MANDATORY
SERVICE BULLETIN

Service Bulletin No. 545A
(Supersedes Service Bulletin No. 545)
Engineering Aspects are
FAA ApprovedSUBJECT: **Part I.** Oil Filler Tube Inspection/Replacement
Part II. Kit Installation ModificationMODELS AFFECTED: I. All Textron Lycoming TIO-540-AJ1A and IO-540-AC1A5 aircraft engines shipped from the factory before October 30, 2000, unless Kit P/N 05K23081 has been installed.
II. All Textron Lycoming TIO-540-AJ1A and IO-540-AC1A5 aircraft engines that have had Kit P/N 05K23081 installed before May 1, 2001.TIME OF COMPLIANCE: I. Inspect within the next 10 hours of operation and replace within the next 50 hours of operation.
II. Inspect at next oil change and modify installation, if required.**PART I**

Figure 1

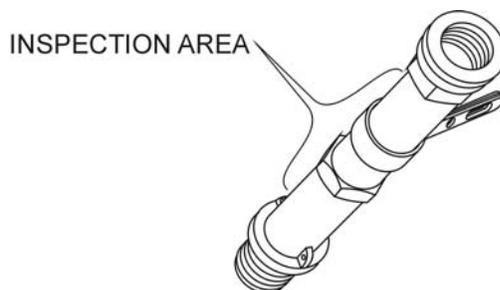
It has been determined that the existing oil filler tube installation could allow the clamp holding the tube to exert downward stress. This could result in damage to the filler tube.

In order to insure the structural integrity of the oil filler tube, it is necessary to inspect for gaps, openings, or damage to the tube and for the security of the clamp that supports the oil filler tube.

1. If Kit P/N 05K23081 has been installed (see Figure 2) proceed to Part II. If Kit P/N 05K23081 has not been installed, inspect tube (see Figure 1) for signs of gaps, cracks, leaks or damage. If damaged, replace before further flight.
2. Be sure that the clamp supporting the tube is not exerting downward pressure on the tube.

Figure 2

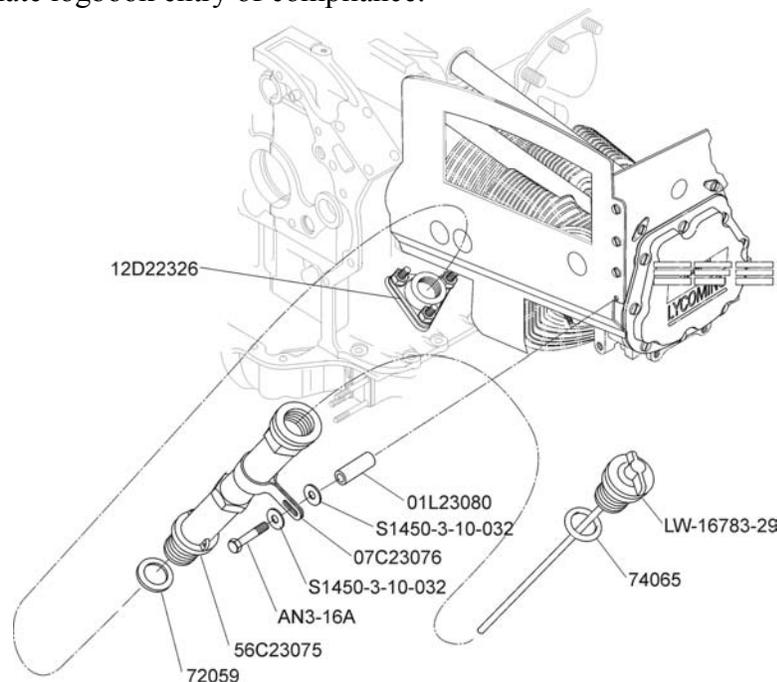
Since October 30, 2000, a new oil filler tube/dipstick and clamp arrangement has been installed on all TIO-540-AJ1A and IO-540-AC1A5 engines shipped from the factory. Engines shipped on or after October 30, 2000 are not affected by PART I of this Service Bulletin. For affected engines, the installation of Oil Filler Tube Kit P/N 05K23081 (includes new clamp) fulfills compliance with the replacement requirement of this Service Bulletin.

1. Remove safety wire from the base of the oil filler tube.
2. Remove the clamp and hardware securing the filler tube to the engine.
3. Unscrew the filler tube from the base.
4. Install new dipstick P/N LW-16783-29 and o-ring P/N 74065 with new fill tube P/N 56C23075.
5. Install the new P/N 72059 gasket furnished in the kit onto the new filler tube assembly.
6. Install new filler tube P/N 56C23075 by screwing it securely into the base.
7. Install clamp P/N 07C23076 as shown in Figure 2. Using the bolt, 2 washers, and spacer as shown in Figure 2, and taking care that the tube is not preloaded, attach the clamp to the engine baffle. Torque the bolt to 49 in.-lbs.

If there is a preload in any direction, check to be sure the correct adapter (P/N 12D22326) is installed. Replace if necessary.

8. Safety wire the base of the filler tube.
9. Make an appropriate logbook entry of compliance.

Figure 3.

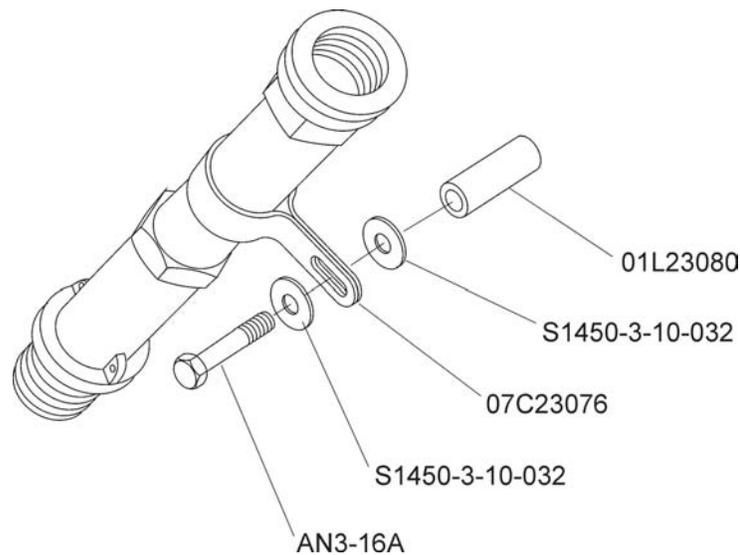
Subsequent to the original release of Oil Filler Tube Kit P/N 05K23081, the type, quantity and configuration of the washers have been modified.

If Kit P/N 05K23081 has been installed, refer to Figure 3. If two P/N S1450-3-10-032 washers are installed, no further action is required. If one S1450-3-8-032 washer is installed replace it as follows:

1. Remove the P/N AN3-16A bolt; retain the P/N 01L23080 spacer.
2. Discard the P/N S1450-3-8-032 washer.
3. Inspect the clamp (P/N 07C23076). If cracked or damaged, replace.
4. Reinstall the P/N AN3-16A bolt and the P/N 01L23080 spacer, using one P/N S-1450-3-10-032 washer under the bolt head and one between the bracket and spacer as shown in Figure 3. Torque the bolt to 49 in.-lbs.
5. Make an appropriate logbook entry of compliance.
